Land South of Holt Road

Addendum to Design & Access Statement

December 2020

Extract from CBO Transport plan ref CBO-0322-017

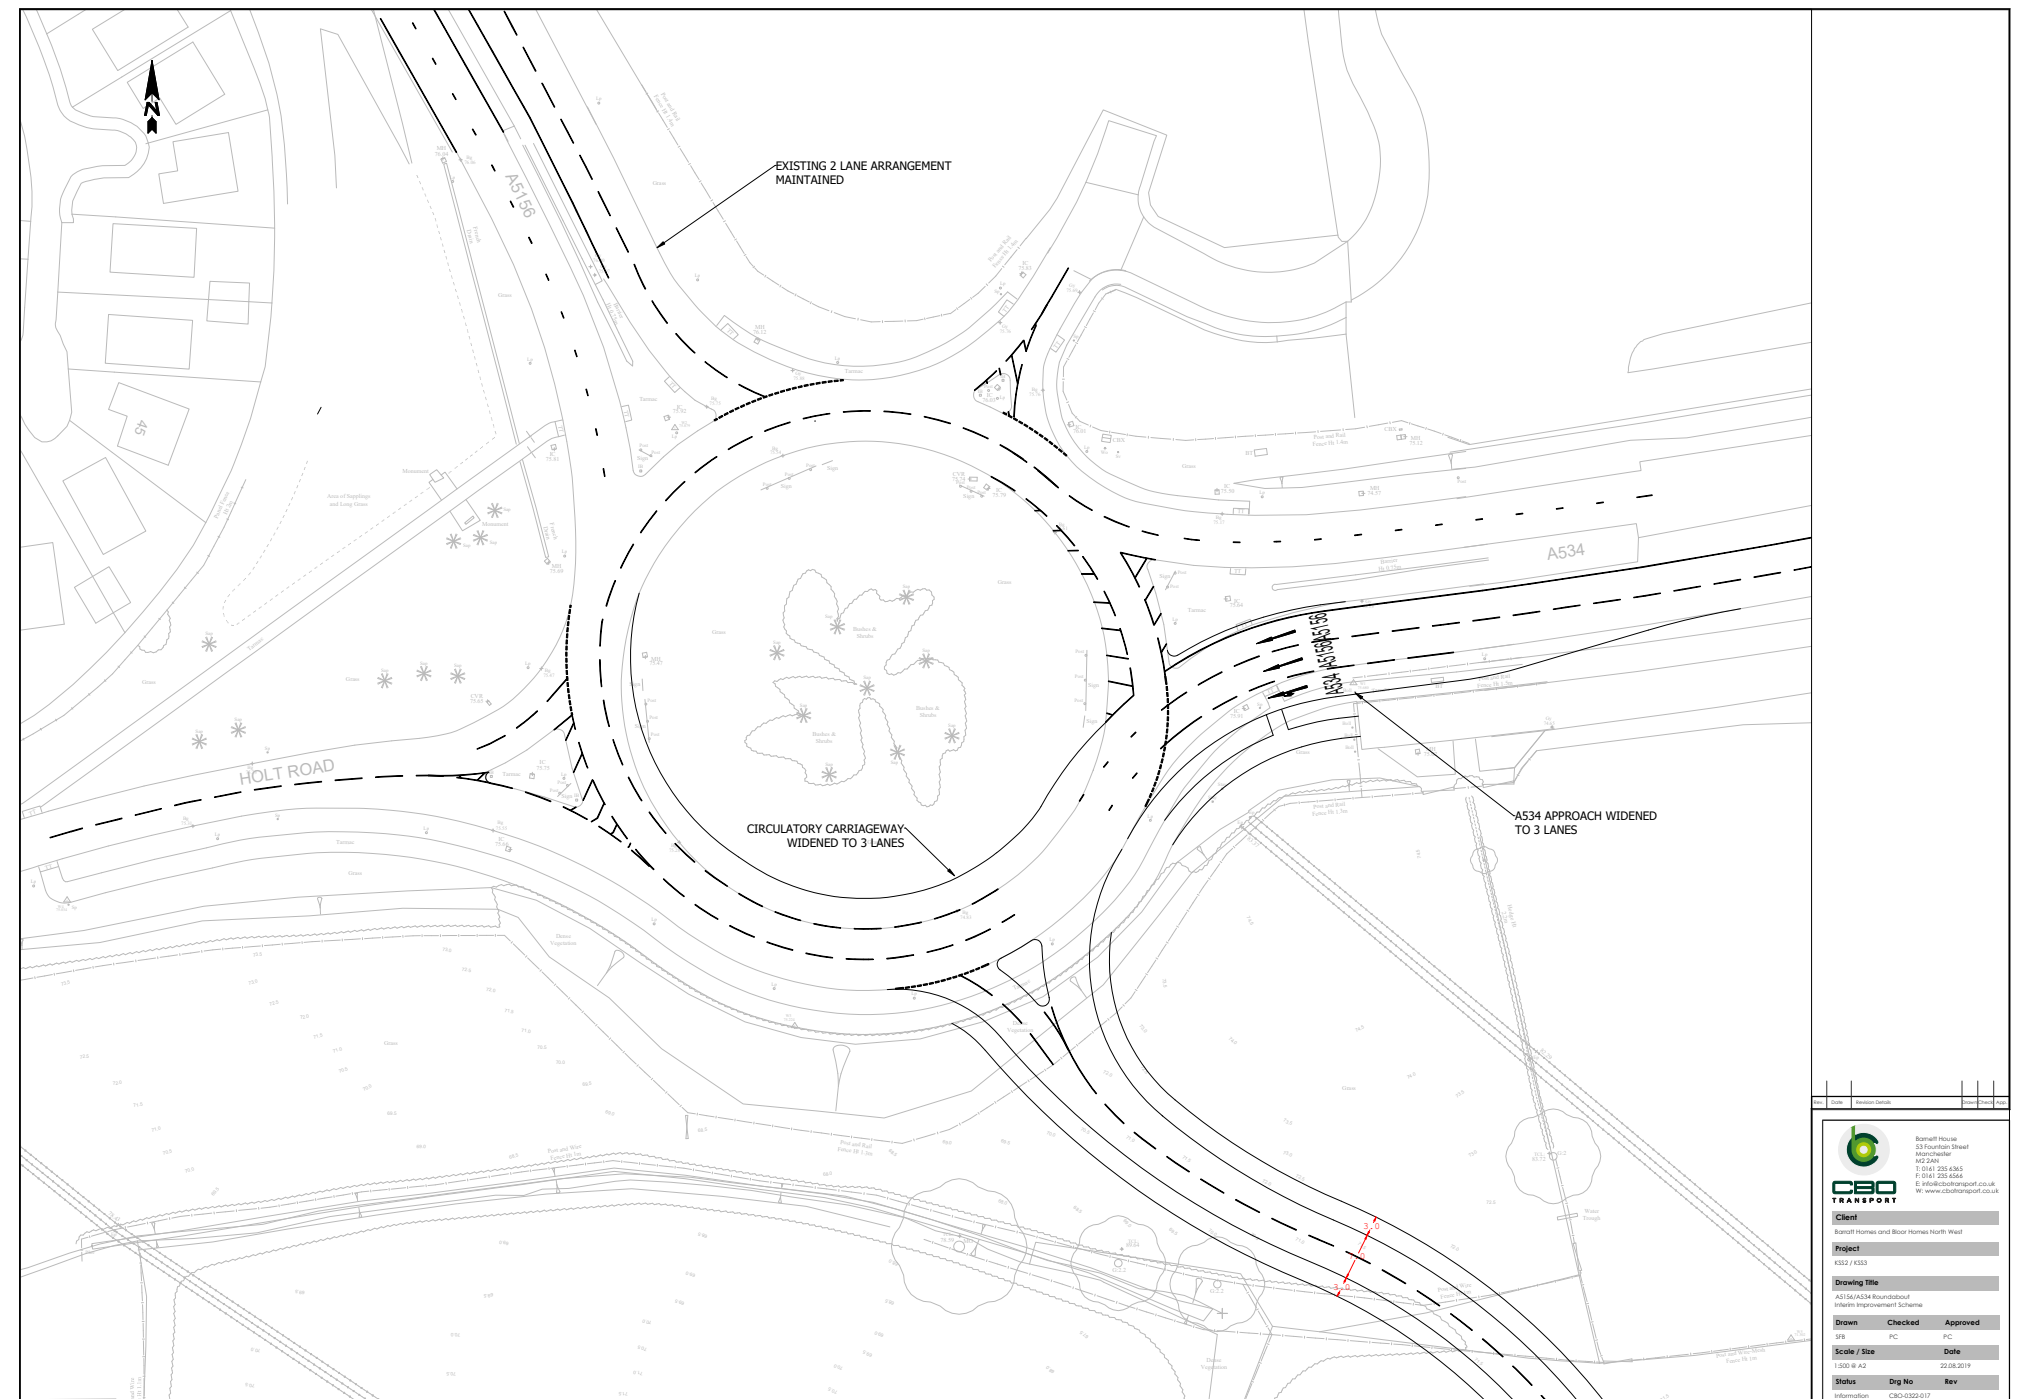
A revised access plan for the new spur off the A534 and A5156 roundabout is submitted as part of this application to reflect the agreed position during the previous application; see extract.
